# CITY OF ALBUQUERQUE

**RE: NM Boys & Girls Ranch  
Grading and Drainage Plan  
Engineer's Stamp Date: 03/18/24  
Hydrology File: D13D019**

Based upon the information provided in your submittal received 03/15/2024, the Grading & Drainage Plan **is not** approved for Building Permit and Grading Permit. The following comments need to be addressed for approval of the above referenced project:

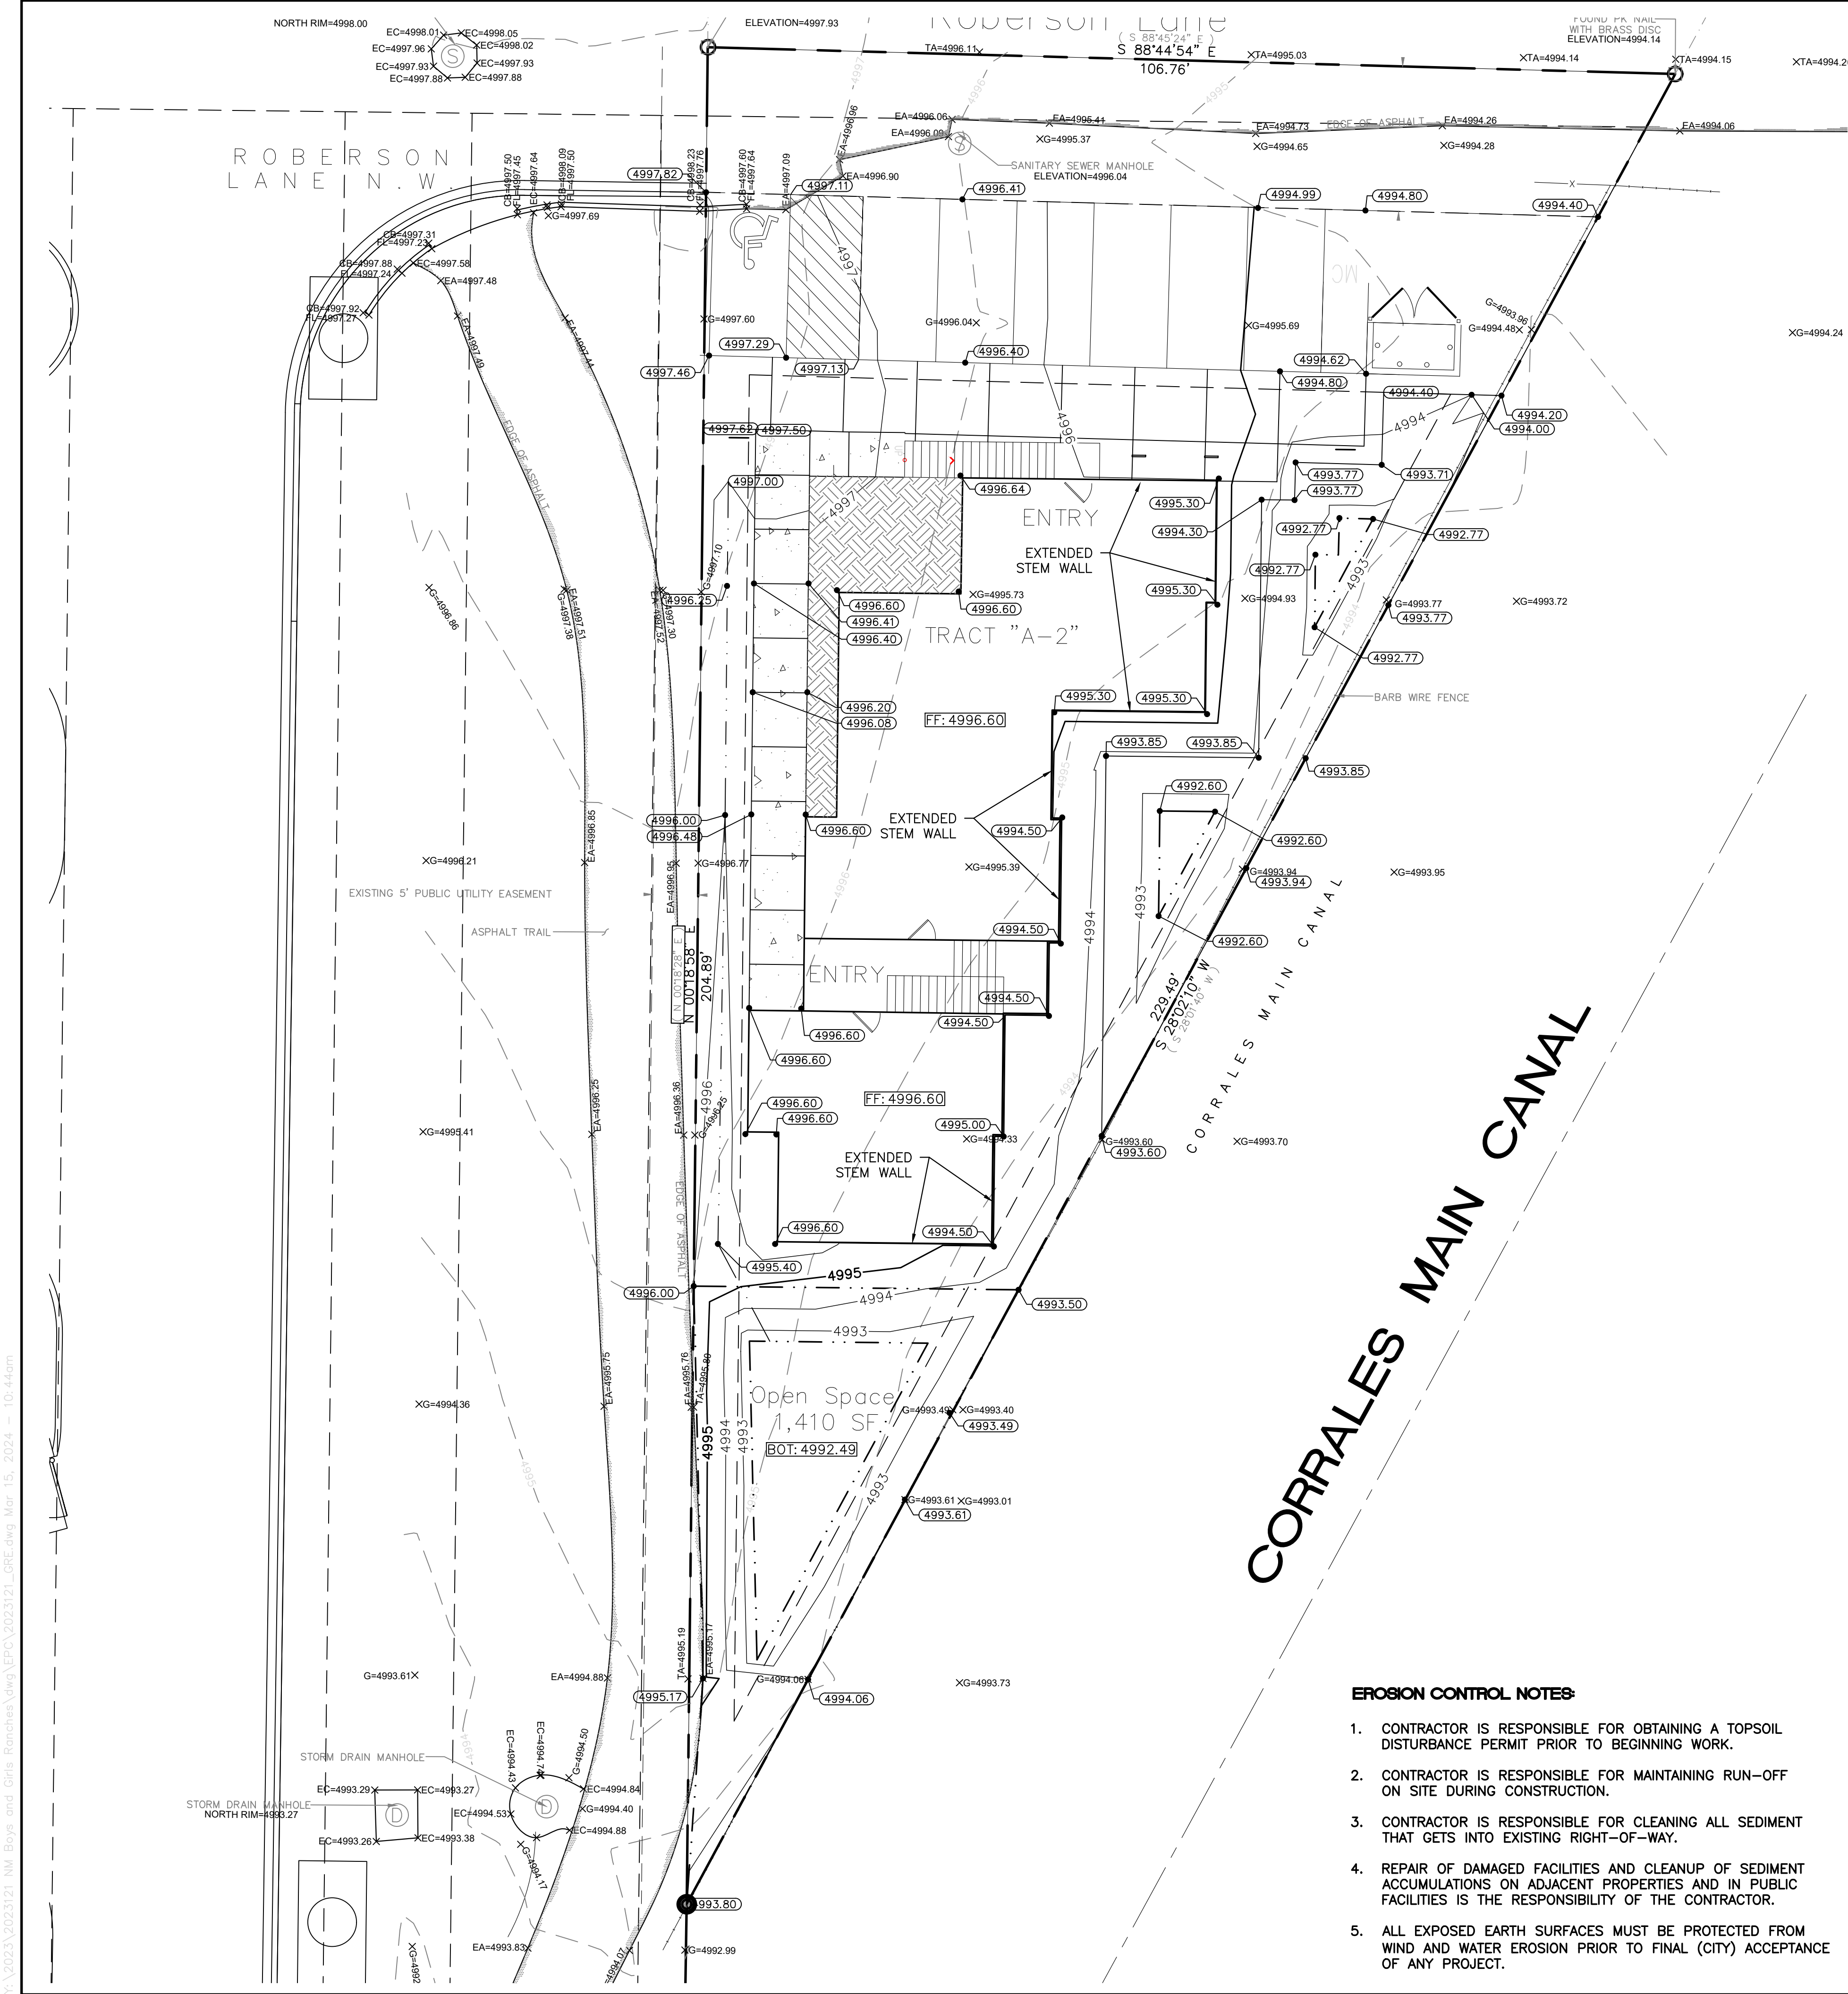
2. The whole Drainage Management Plan section is incorrect and appears to be just copied from a previous project. This site is part of the North Coors DMP – Middle Area done by Smith Engineering dated Feb 1997. In this DMP this site is part of a 7.168 acre drainage area that can discharge only 26 cfs. Therefore the site can discharge 3.63 cfs/ac and since the site is only 0.87 acres, it can only discharge 0.87 cfs into the Corales Canal.

3. Please adjust the ponds to not only detain the difference between the proposed sites discharge of 1.37 and the allowable rate of 0.87 cfs, but also the required Stormwater quality pond volume for a new developed site. SWQ volume is equal to new impervious area (building, paving and sidewalks) in square feet \* 0.42 / 12 to give the required volume in cubic feet.
